**NRC/TN Meeting
CoC 9302 MP197HB
RAI Discussions
January 14, 2010**

RAIs for Discussion (non-proprietary-information)

Impact Limiter Analysis - RAI 2-31 (Continued) Hourglass

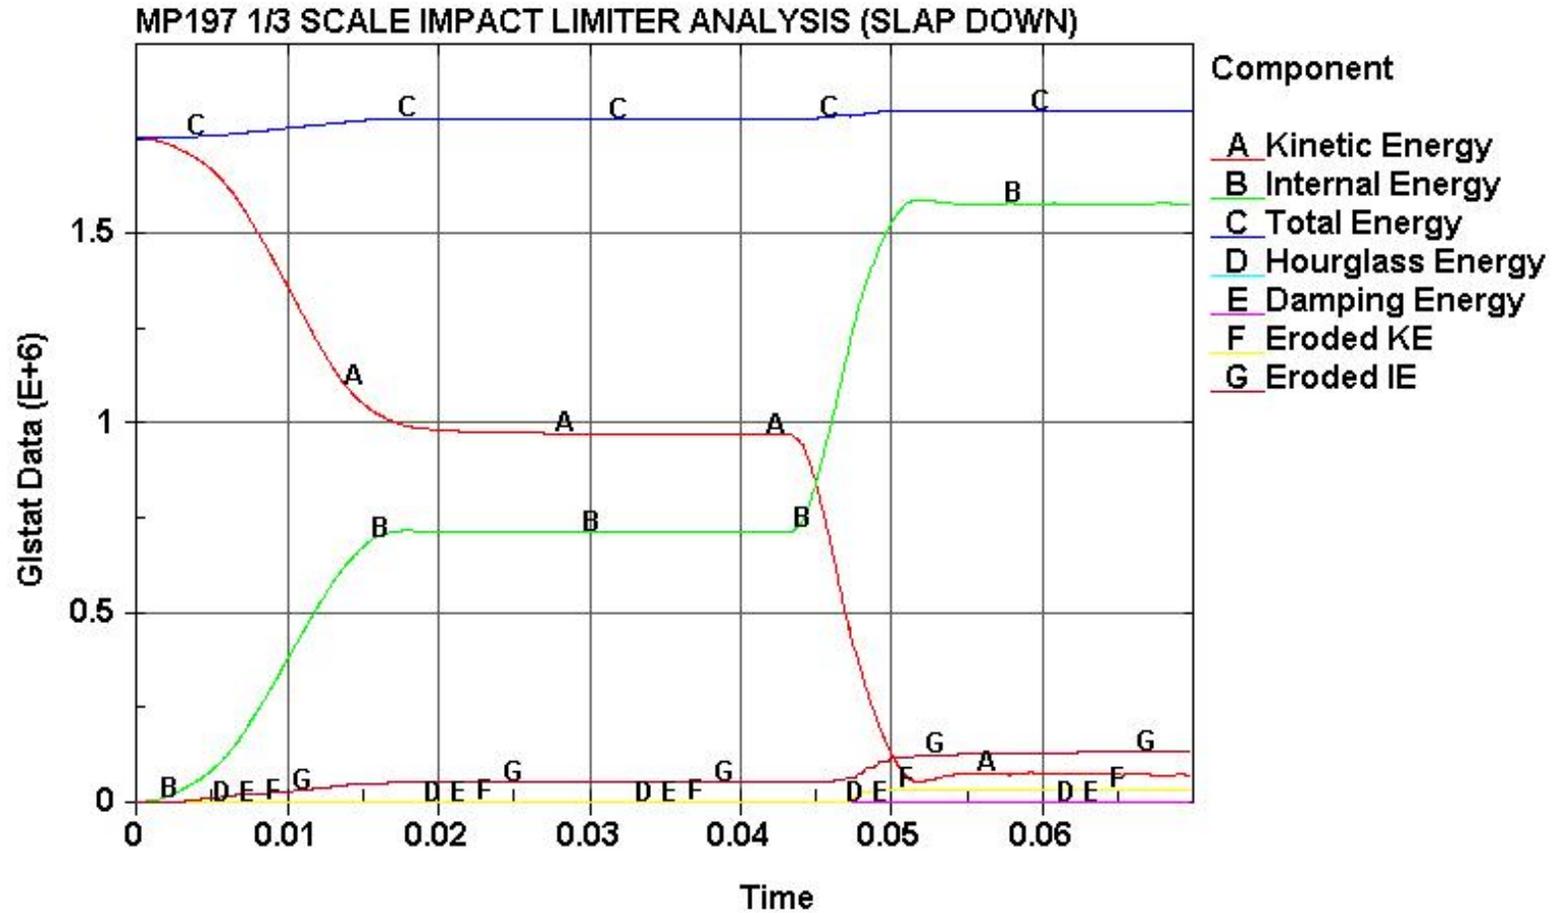
Impact Limiter Analysis - RAI 2-31

- Selectively reduced elements were chosen to reduce hourglassing
- The energy results for the 1/3 slapdown case show that the element distortions are a result of contact issues rather than hourglassing
- Contact definitions will be modified so as to resolve distortion
- Sensitivity Analysis will be performed to study the effect of selectively reduced elements vs constant stress elements

Impact Limiter Analysis - RAI 2-36 and 2-37 Node Locations for Accelerations

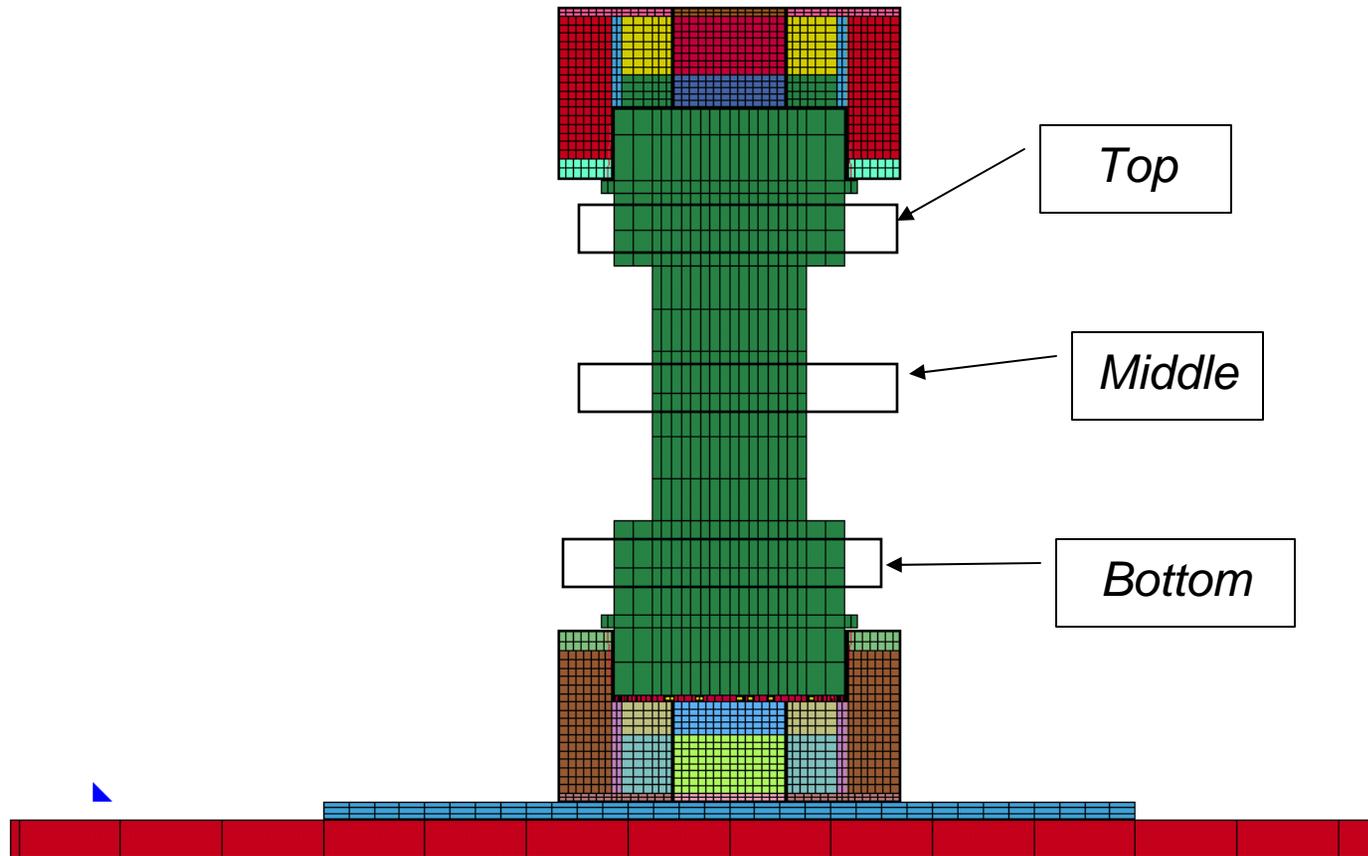
- The accelerations at all nodes in middle region were averaged for the end and side drop analysis and compared against the averaged accelerations from the accelerometer
- The accelerations at all of nodes in top and bottom regions were averaged for the slapdown analysis and compared against the averaged accelerations from the accelerometer at the top and bottom of the cask, respectively.
- The locations of the nodes for the top, middle, and bottom regions will be added to the SAR

RAI 5-18 Response Function

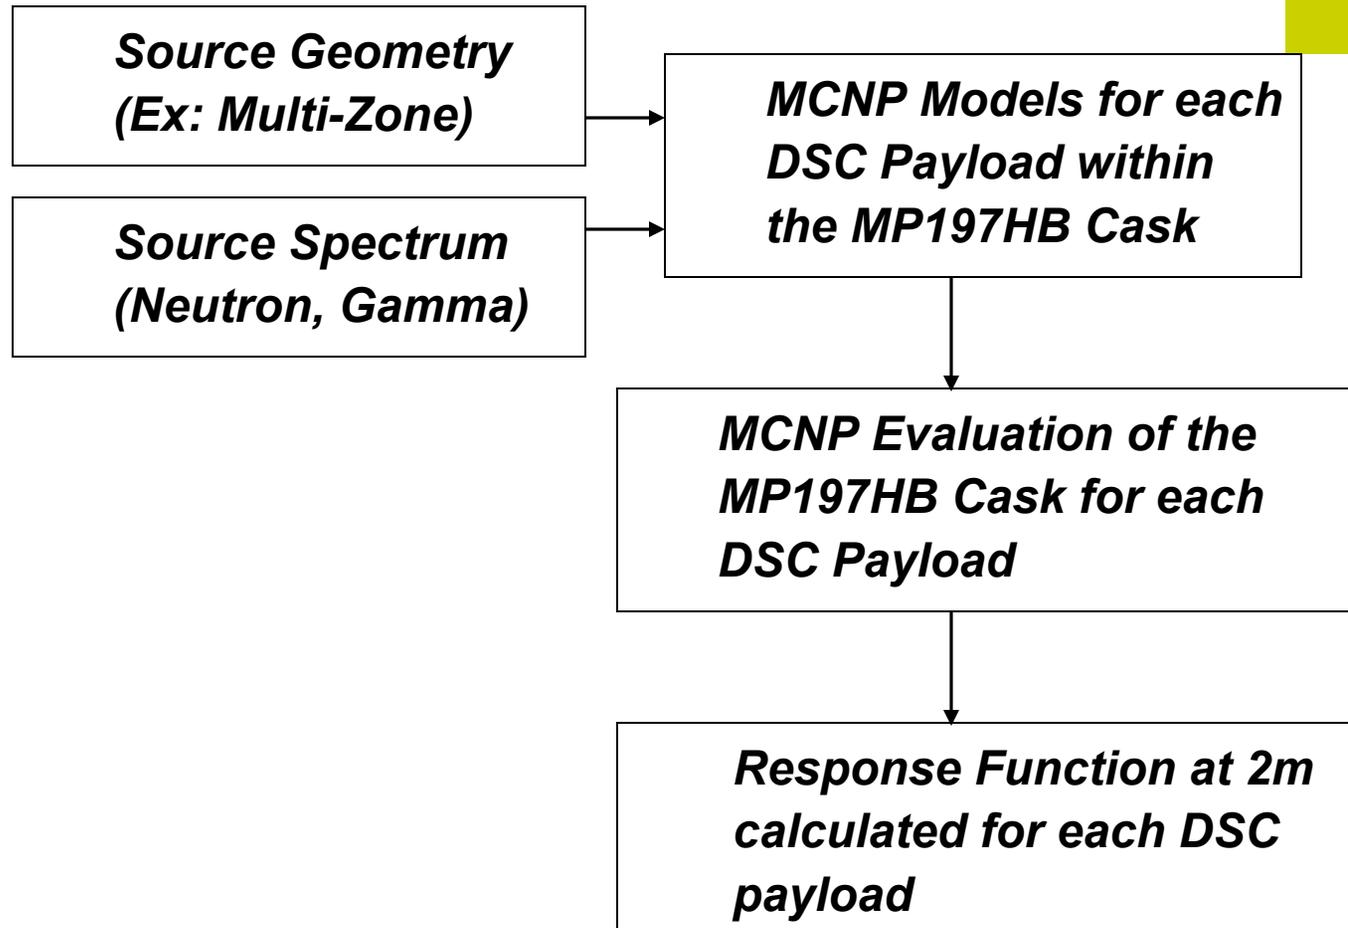
- A new Appendix will be added to Chapter A.5 to describe the Response Function Methodology
- Response Function is simply a dose rate ranking methodology and is based on MCNP results as a function of DSC Type and Energy Group
- Fuel Qualification Tables (FQTs) for shielding are generated using the Response Functions for each DSC to determine acceptable combinations of Burnup Enrichment and Cooling Time (BECT)
- The FQTs are designed such that any given BECT combination results in approximately the same dose rate at 2m under NCT
- The dose rates from Response Functions will be presented in the Appendix including the neutron and gamma contributions
- The dose rate calculated from Response Functions will also be compared to the MCNP results for selected BECT combinations

RAI 5-18 Response Function

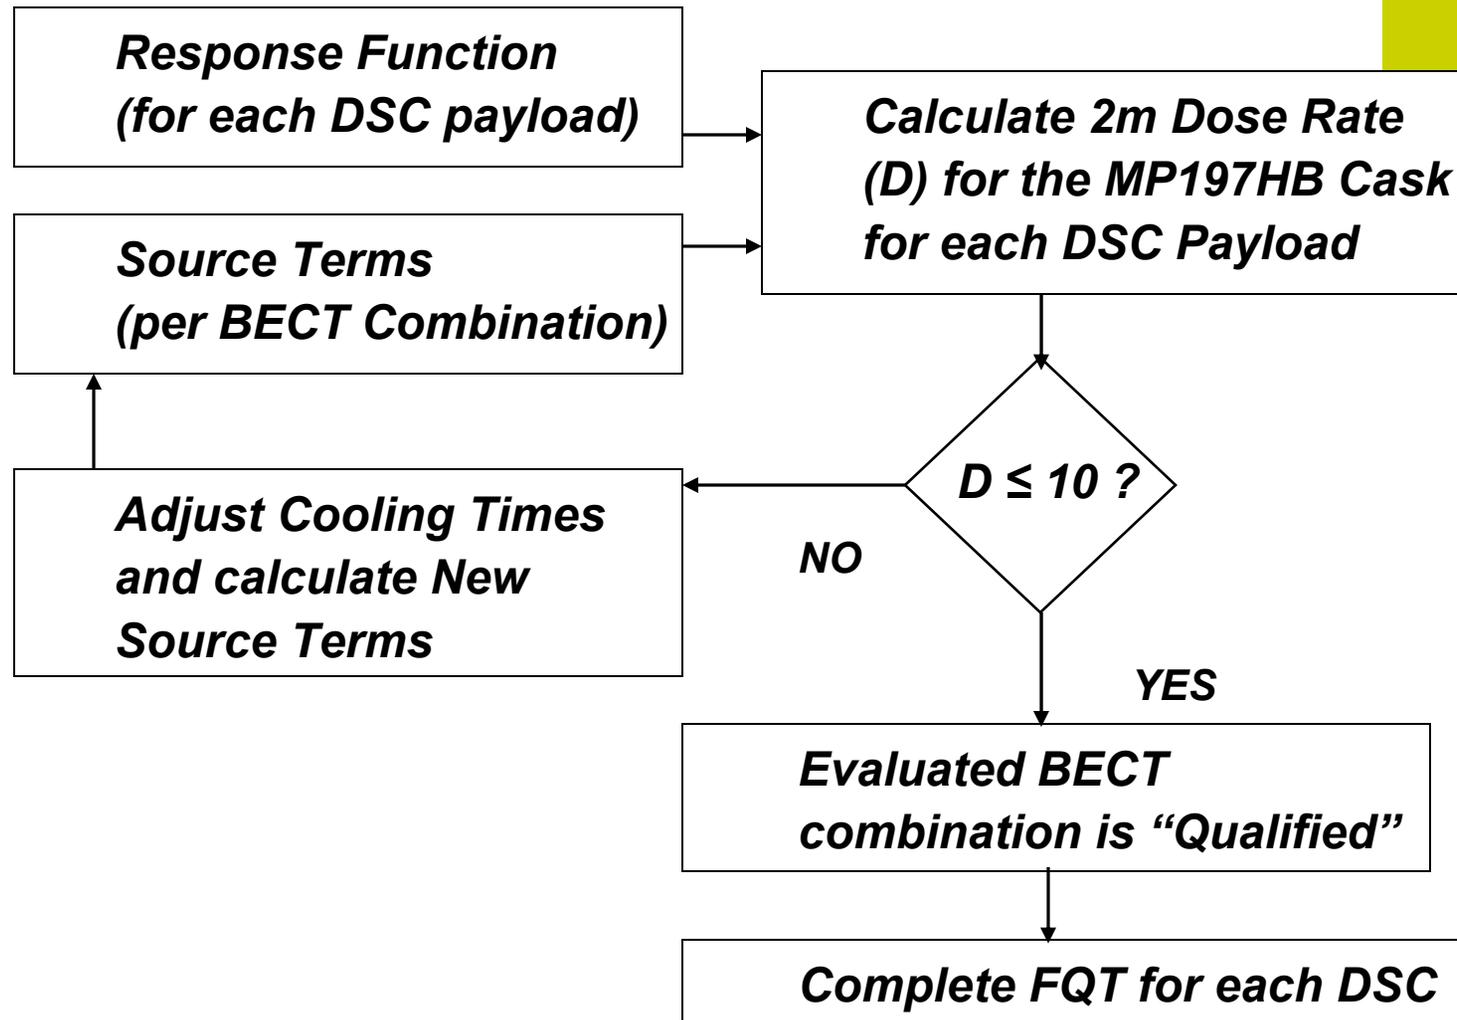
➤ **An Example 4-Zone Response Function (2 m radial dose point) for the 69BTH DSC is shown in the Table below**
